MOUNT EVERETT ACADEMY  
STABILIZATION AND ADA IMPROVEMENTS

**ADDENDUM THREE**

December 7, 2021

**MOUNT EVERETT ACADEMY/EGREMONT FREE LIBRARY  
SOUTH EGREMONT, MASSACHUSETTS**

**Techno Metal Post  
Model P2  
(Above ground light  
structure)**

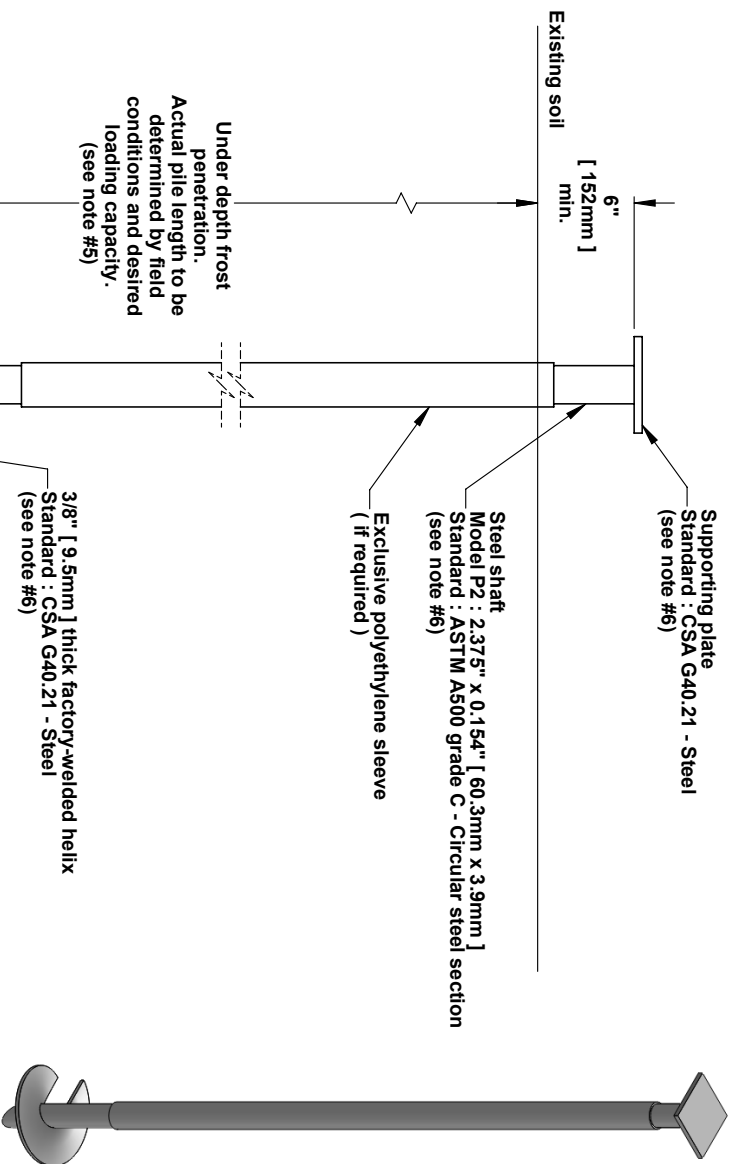
- 1. Question:** Can we use helical posts instead of concrete piers?

**Response:** Yes, please use galvanized helical piers instead of concrete piers for the ramp construction. Two additional piers will need to be added on the long, adjacent runs of the ramp for a total of 15 piers. See Basis of Design spec attached.
